CITY OF TUKWILA
PLANNING COMMISSION
PUBLIC HEARING
VIRTUAL MEETING VIA MICROSOFT
TEAMS
JUNE 10, 2021 - 6:30 PM

- IV. CASE NUMBERS: L19-0115
- PURPOSE: Adoption of design standards and guidelines for residential development in the Tukwila South Overlay District.
- LOCATION: Tukwila South Overlay District; north of S 204th St, west of Duwamish River, south of S 180th, east of Orillia Rd/I-5

STAFF REPORT TO THE PLANNING COMMISSION

- FILE NUMBER:** L19-0115 Comprehensive Plan/Zoning Code Amendment
- ASSOCIATED FILES:** E19-0011 SEPA Checklist
- REQUEST:** Zoning Code amendments to TMC 18.41 and new design guidelines for multifamily development in the Tukwila South Overlay (TSO) district.
- Planning Commission (PC) will hold a future public hearing on the proposed amendments and make recommendations to the City Council for review and adoption.
- PUBLIC HEARING:** The June 10, 2021, meeting is a continuation of the public hearing that commenced on March 18, 2021.
- LOCATION:** Lands within the Tukwila South Overlay district.
- STAFF:** Max Baker, Senior Planner
- ATTACHMENTS:**
- A. 4.22.2021 PC Meeting Staff Report – Applicant Comments Provided 4.22.2021 + Staff Responses
 - B. Draft

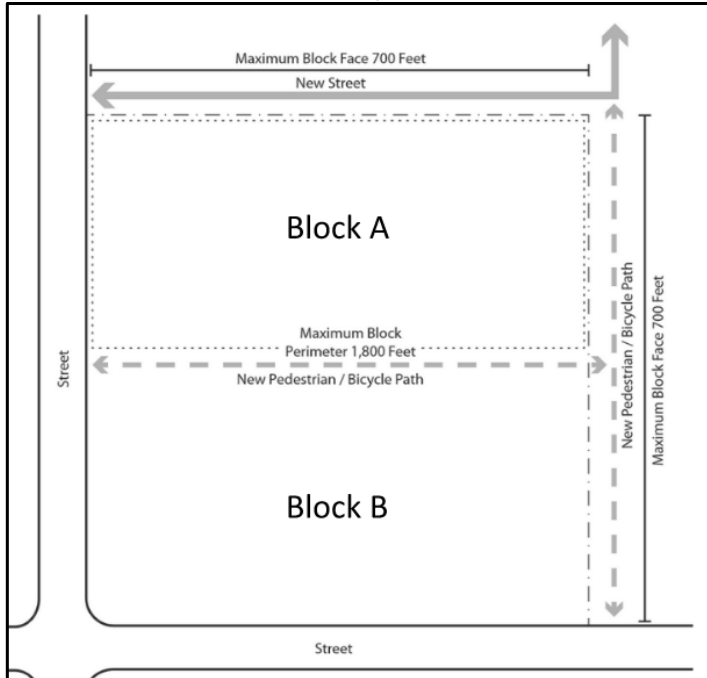
Commented [MP17]: Segale suggest this redlined language may be easier to measure as the perimeter is easy to find as opposed to 50% of the proposed units.

Commented [MP19]: Unless I am mistaken the connectivity and circulation language is a guideline and not a standard. Given that, should the opening sentence read "in addition to the development standards revisions discussed above, staff recommends additional guidelines to aid in ensuring residential connectivity is provided through the residential component of the project.

Commented [MB18R17]: Staff recommends using suggested language for proximity to recreation areas: "The closet structure containing residential units (not including accessory buildings such as fitness centers, parking garages, utility structures, etc. must be located within ¼ mile..."
